## Service Bulletin No. 392B

MODEL	D Series	TYPE	Field Change Program	SECTION/GROUP	7 – Electrical	DATE	Sept. 18, 2013
SUBJECT	ACTIA MULTIPLEX INTERFACE WITH CUMMINS 2010 ENGINE						
CONDITIONS

**Figure 1. Program Rev. Level decal located on the front junction box frame.**

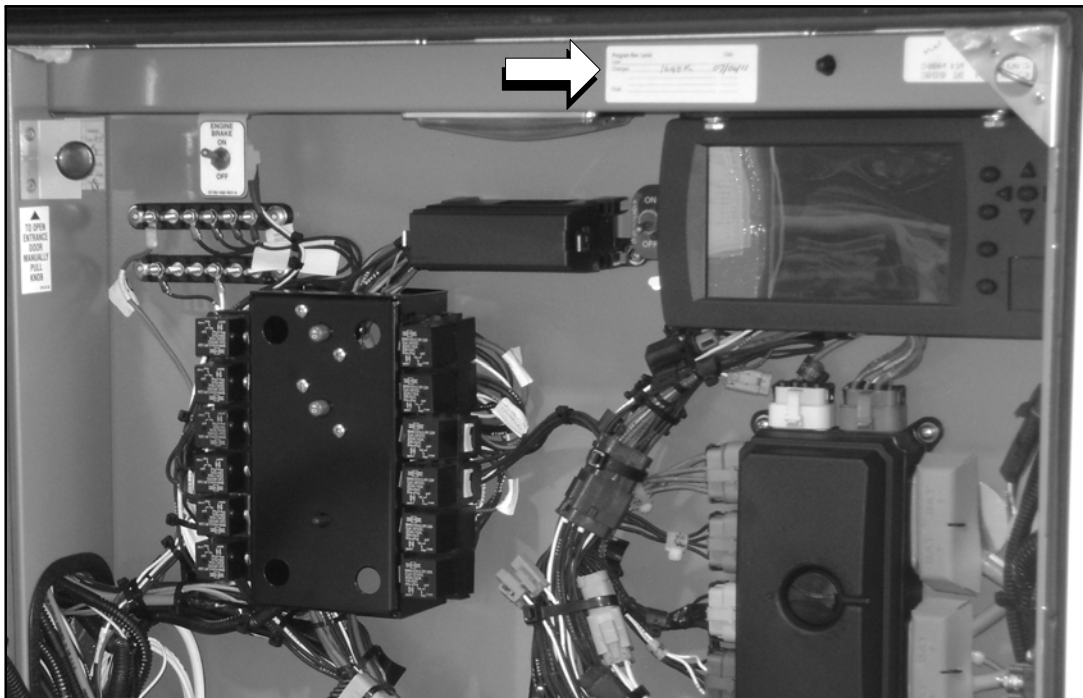
1. Position the rotary dial on the lower, LH console switch panel to ENGINE STOP. Ensure the main battery disconnect switch is in the ON position.
2. Connect the laptop to the coach, equipped with Amp reflash software, and download the new control logic.
3. Open the front junction box door. Locate the Program Rev. Level decal in the upper, RH corner ( refer to Figure 1 ).
4. Using a marker or pen, clearly print to update the Program Rev. Level decal by recording the new control logic revision level and the date the download occurred on the applicable line of the decal.
